Charlotte Department of Transportation

Memorandum

Subject: Rezoning Petition 13-067: Approximately 18.95 acres located on the west side of Northlake Centre Parkway near the intersection of Madison Square Place, Northlake Mall Drive and Northlake Centre Parkway.

Figure 1: Northlake Study Area Proposed Street Classifications Map - Northlake Area Plan

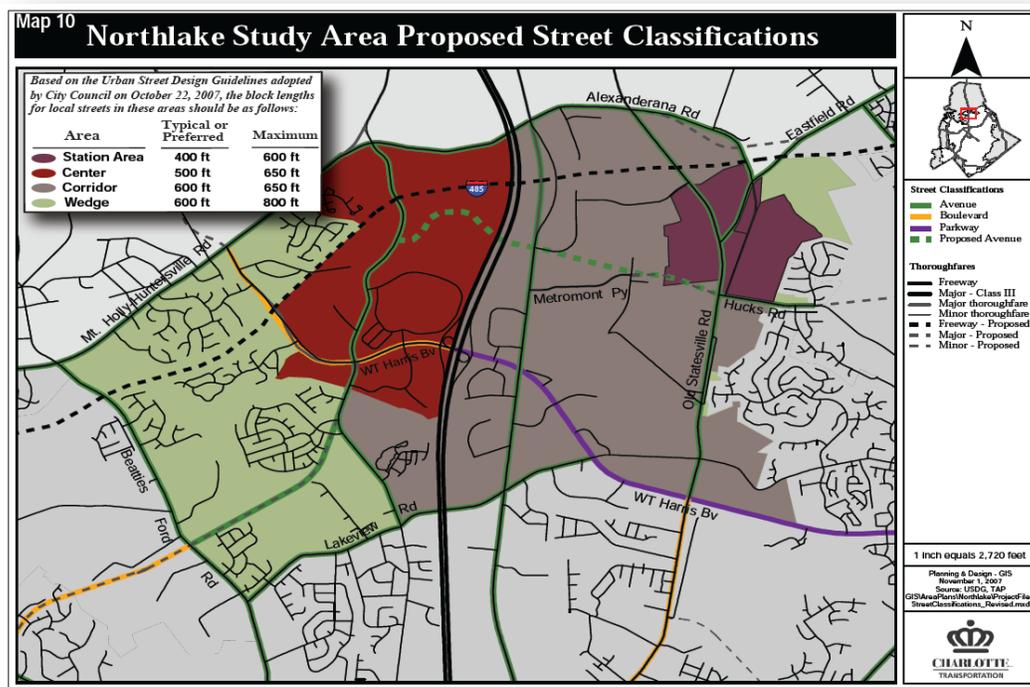
1. Based on the Northlake Area plan (we understand there is a recommended future Hucks Road street extension that will connect to Old Statesville Road to Northlake Centre Parkway Figure 1). While the final location of the proposed street connection to Northlake Centre Parkway has not been determined, we anticipate (if feasible) that it will align with the existing northernmost median opening. We request the petitioner add a conditional note to the proposed rezoning document that acknowledges that any future street connection at the northernmost existing median opening on Northlake Centre Parkway for parcels 025-081-22B & 025-081-23B will be subject to additional engineering design and evaluation, as this connection may function as a future signalized intersection.
